**Market Street  
Marine Terminal  
Functional Replacement Project  
Portsmouth, NH**

# **NHDES Wetlands Permit Application Amendment & Request for More Information Response**

**NHDOT Project 15731  
Federal Project A000(909)  
NHDES File No. 2022-00429**

**RE: NHDES Request for More Information Response  
Standard Dredge and Fill Wetlands Permit Application (RSA 482-A)  
NHDES File Number: 2022-00429  
Subject Property: Market Street Marine Terminal, Portsmouth, Tax Map #119, Lot #5**

PROJECT No.: 5213  
 CAD DWG FILE: S213\_permit\_M\_C-101.dwg  
 DESIGNED BY: SND  
 DRAWN BY: DLM  
 CHECKED BY: NJE  
 SCALE: AS SHOWN  
**C-101**  
 SHEET 8 OF 18

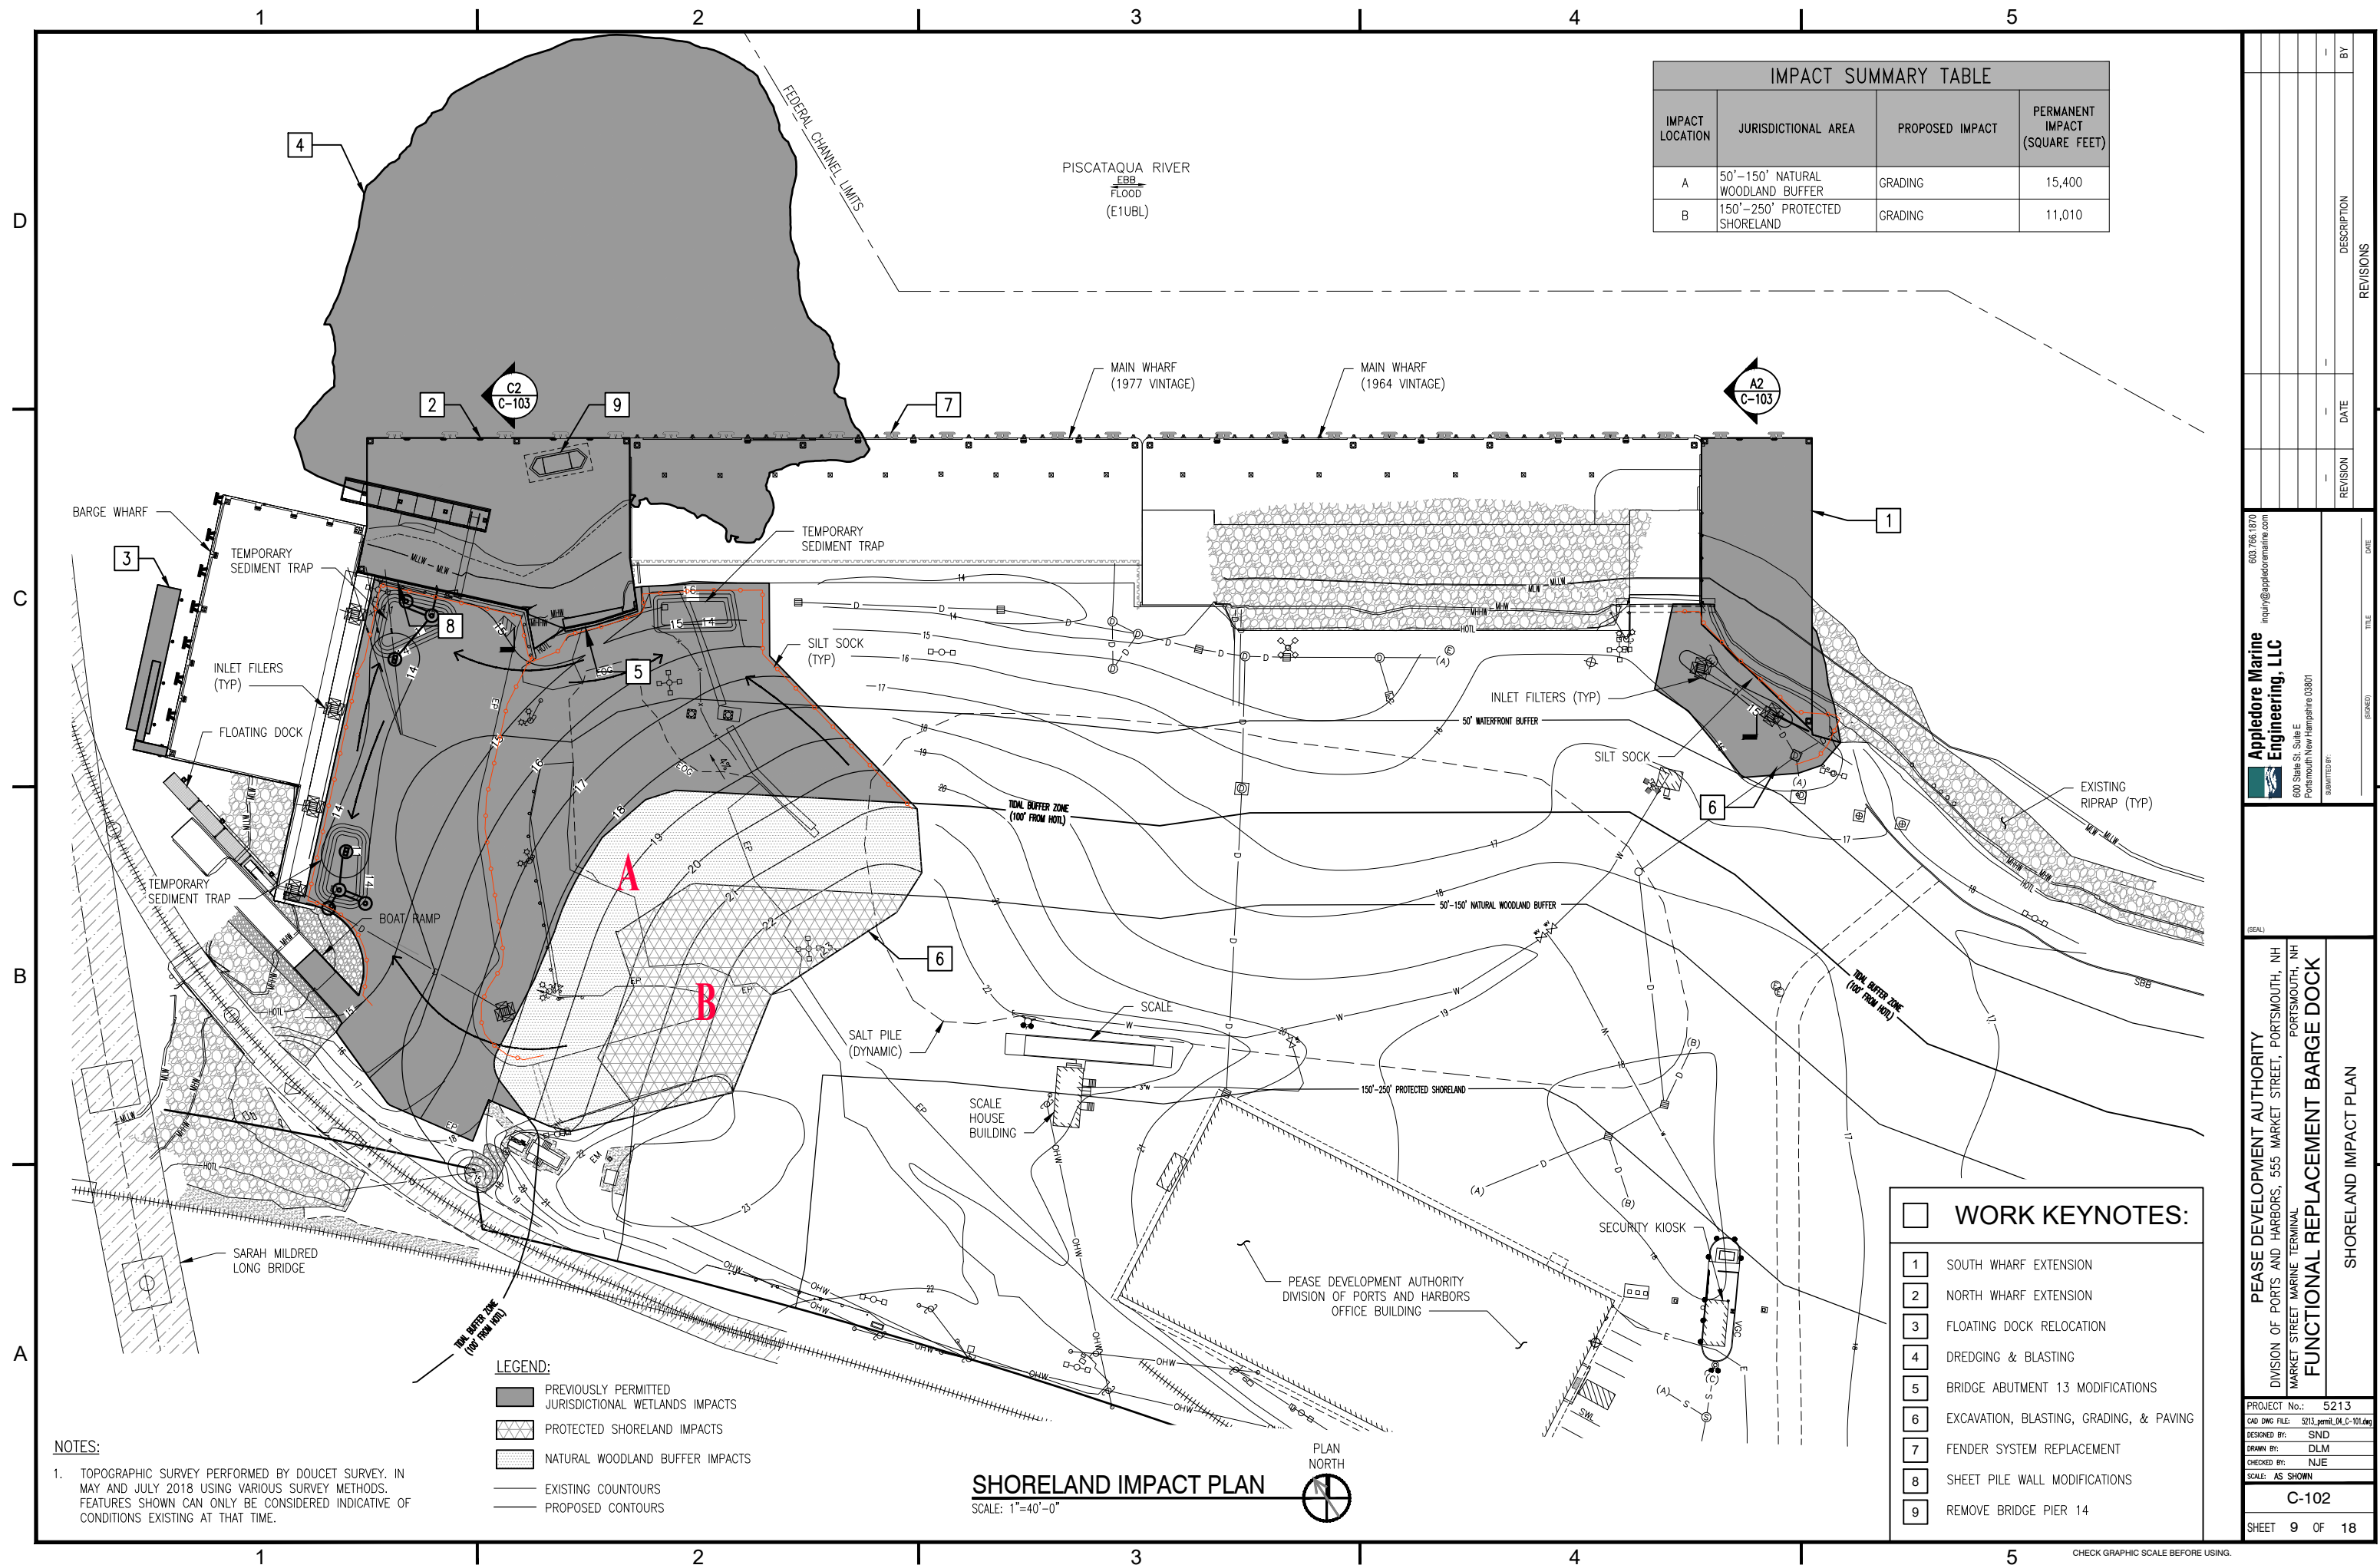
- 
- b. The wetlands classification for all delineated resources identified on plans as required for all major projects in accordance with Env-Wt 301.02(b).

The Piscataqua River is classified as an Estuarine Subtidal System, with an Unconsolidated Bottom, and a Saltwater Subtidal Water Regime (E1UBL). There are no additional wetlands or surface waters delineated in the project area. The E1UBL classification for the Piscataqua River has been added to the plans in accordance with Env-Wt 301.02(b) (see Sheet 8 of 18).

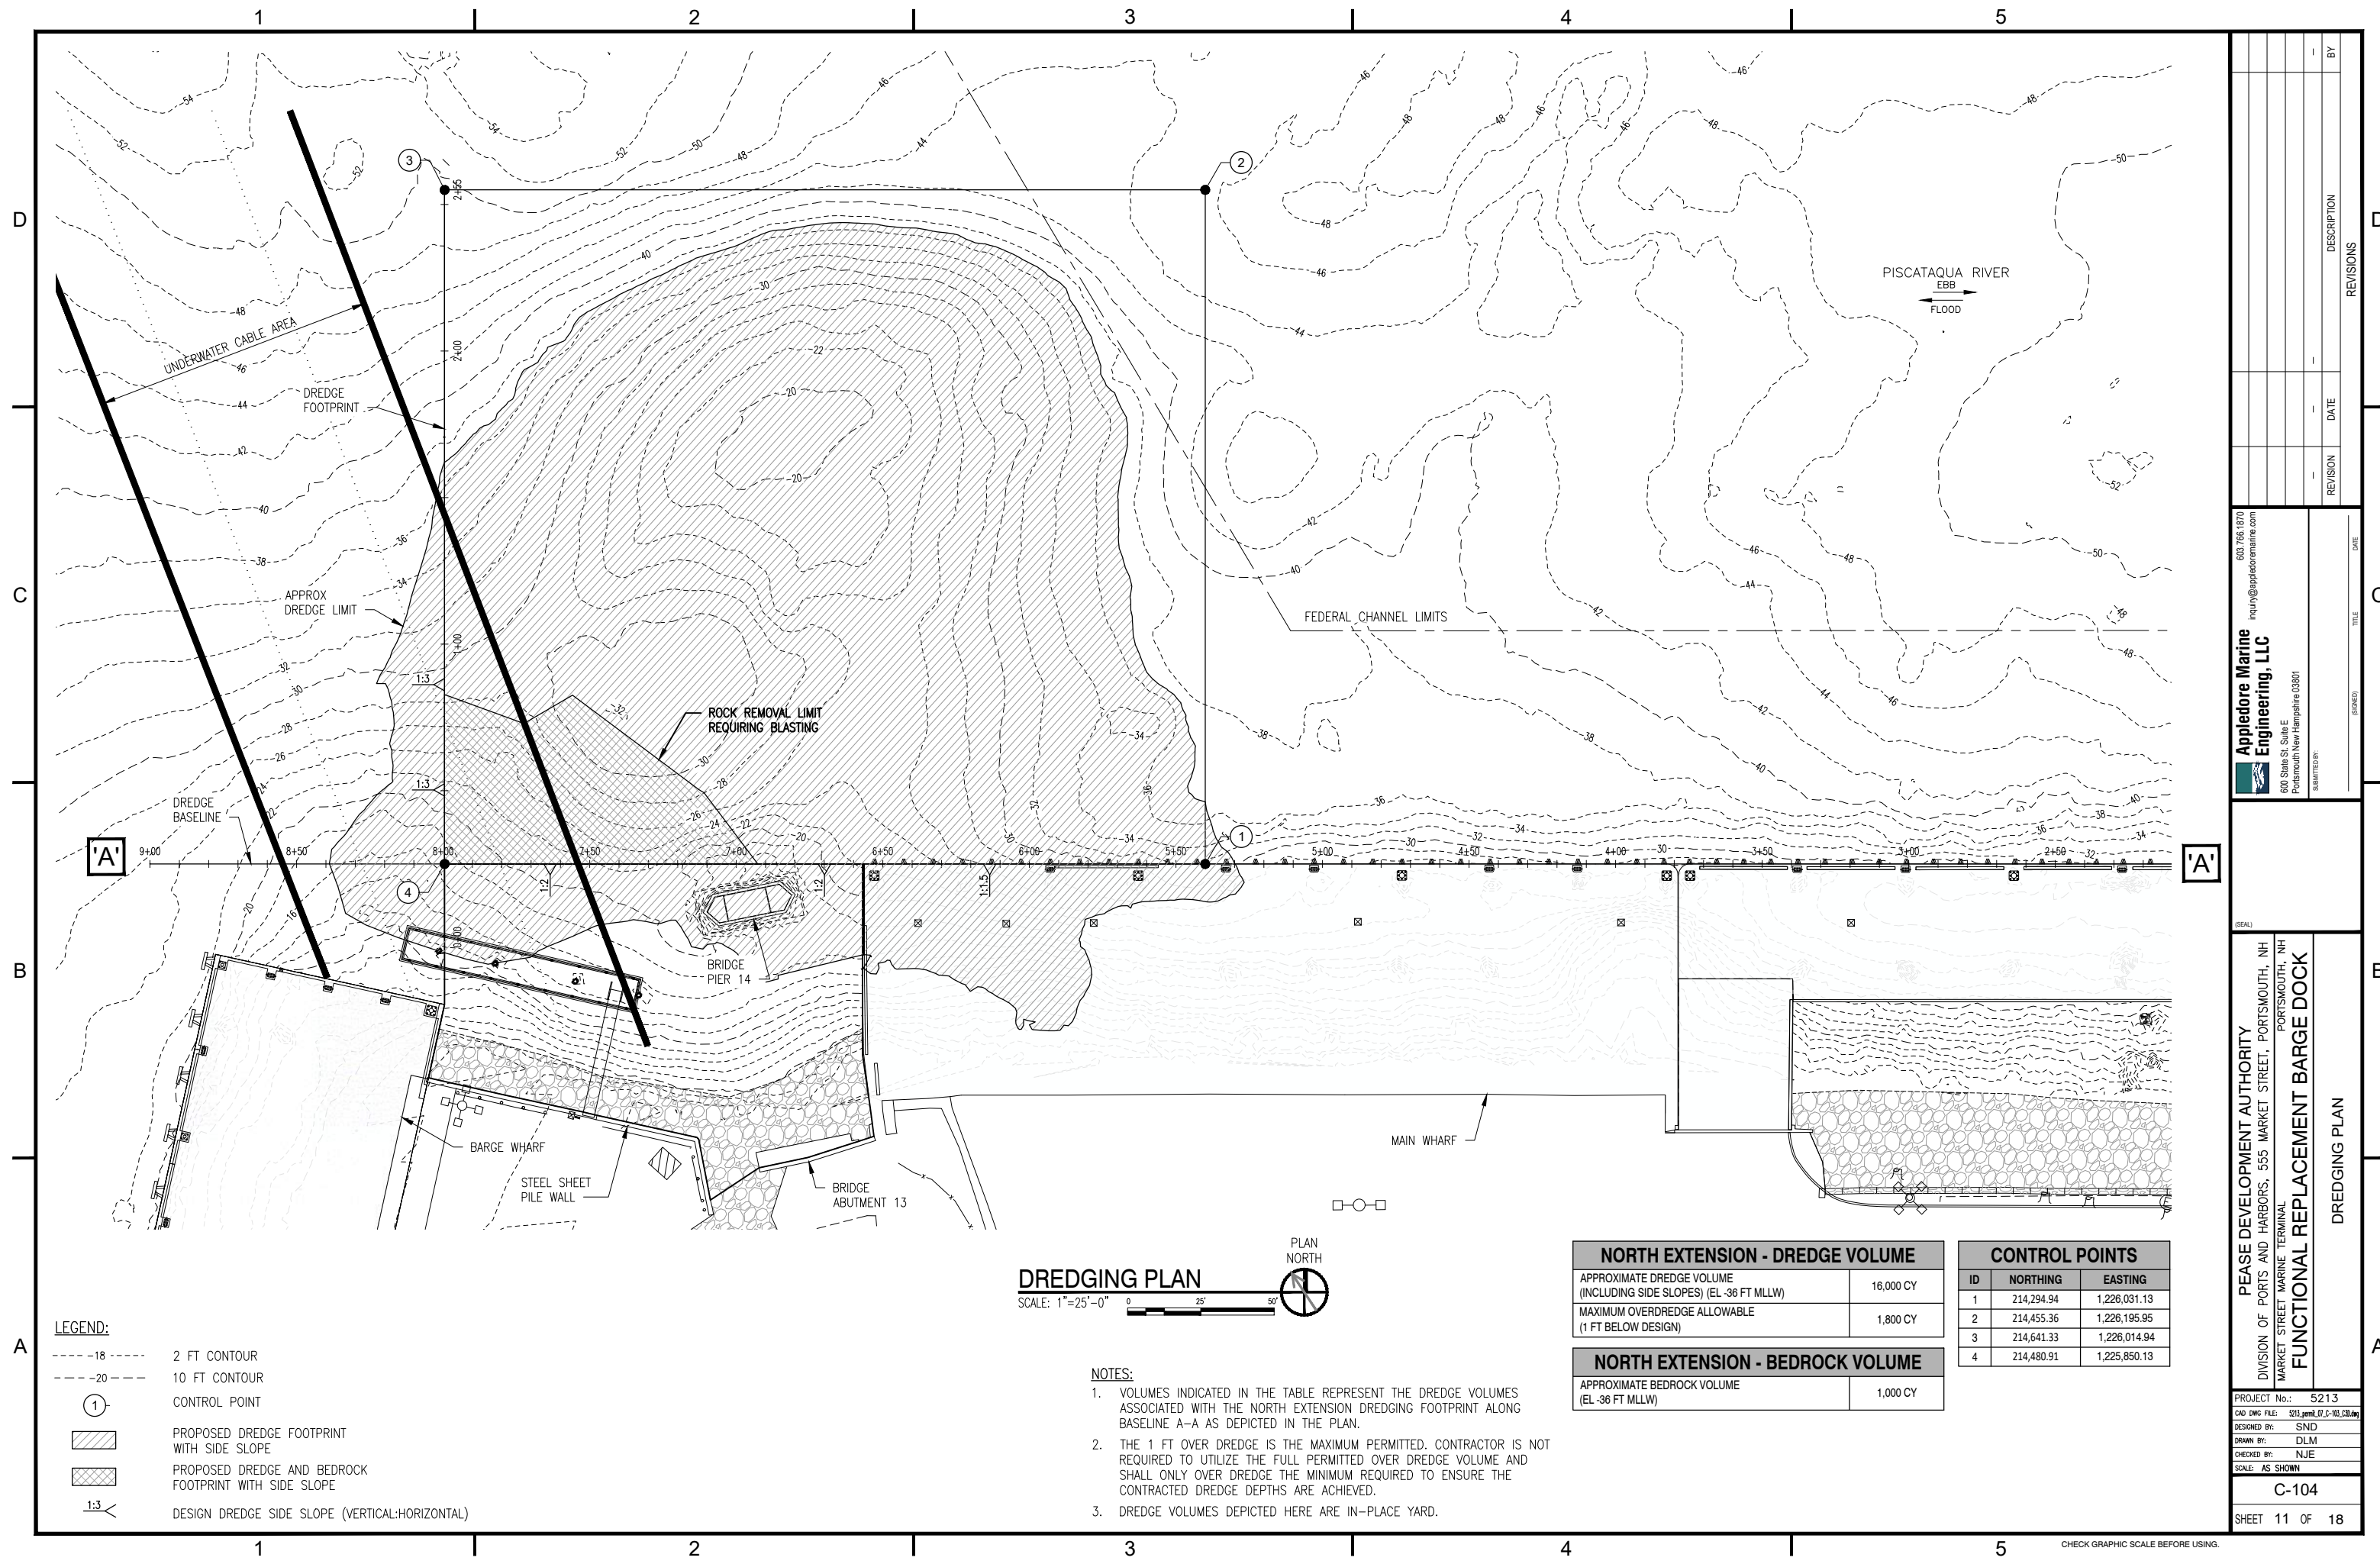
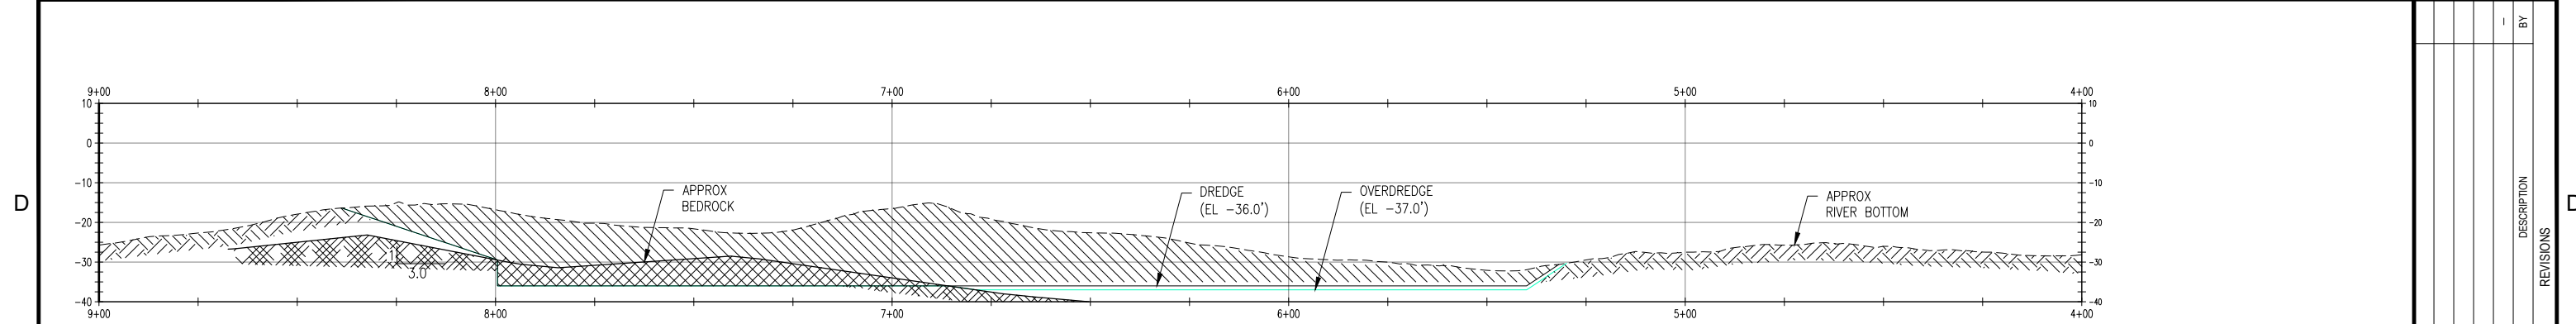
17. Please revise the plans of the proposed dredge area to include cross section details showing the existing and proposed contours within the proposed dredge area at multiple locations through the proposed dredge area in accordance with Env-Wt 501.02(a)(2)(n).

*Please refer to Sheets 11 and 12 of the revised plan set for the proposed dredging area, cross section and profile. The Contractor will be required to complete a pre-dredge and post-dredge hydrographic survey.*
